Access Compliance Report

Public Rights-of-Way

(Curb Ramps)

Intersection ID: 5921	Main Street: COULWOOD_DR	Cross Street: KENTBERRY_DR	Location: W
ADA ID: B66D4C84A19D	Ramp Type: Perp	Initial Pass/Fail: Fail	Overall Compliance: No
Severity Score: 33.75			
Codes/Mitigation Info/Possible Solution		Field Measurements/Component Compliance

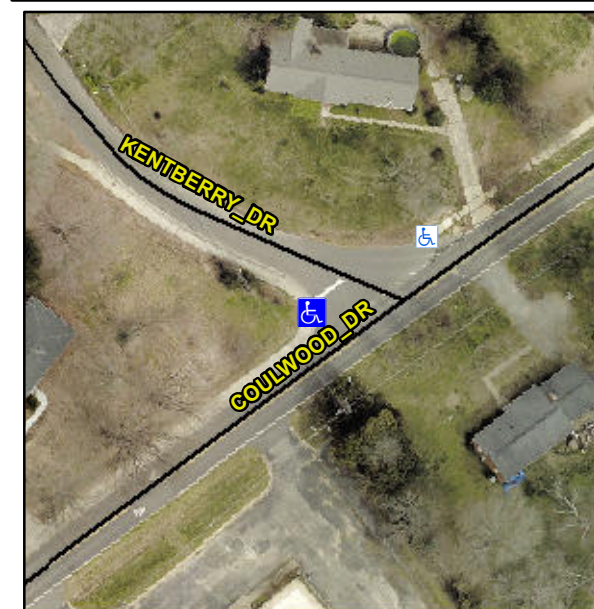
Not Found, R304.5.1, R304.2.2, R304.5.3

Compliance	Description	Data	Compliance	Description	Data
N/A	Ramp Length (in)	72.0	No	Ramp Slope (%)	9.5
No	Ramp Width (in)	45.0	No	Ramp XSlope (%)	6.3
N/A	Flare Type LT	N/A	N/A	Flare Type RT	N/A
N/A	Flare Slope LT (%)	N/A	N/A	Flare Slope RT (%)	N/A
N/A	Flare Traversable LT?	N/A	N/A	Flare Traversable RT?	N/A
N/A	Landing Length (in)	N/A	N/A	DWS Provided?	N/A
N/A	Landing Width (in)	N/A	N/A	DWS Contrast?	N/A
N/A	Landing Slope (%)	N/A	N/A	DWS Length (in)	N/A
N/A	Landing X Slope (%)	N/A	N/A	DWS Full Width?	N/A
N/A	Landing Curb? (Y/N)	N/A	N/A	DWS Offset (in)	N/A
N/A	Shared Landing?	N/A			
N/A	Gutter Ponding?	N/A	N/A	Gutter Slope (%)	N/A
N/A	Gutter Lip Ht (in)	N/A	N/A	Gutter X Slope (%)	N/A
N/A	Painted X Walk1?	No	N/A	Painted X Walk2?	N/A
	X Walk 1 Direction	To NE		X Walk 2 Direction	N/A
N/A	X Walk 1 Width (in)	N/A	N/A	X Walk 2 Width (in)	N/A
	X Walk 1 Slope (%)	5.7		X Walk 2 Slope (%)	N/A
	X Walk 1 X Slope (%)	4.8		X Walk 2 X Slope (%)	N/A

Remove & Replace Entire Ramp.
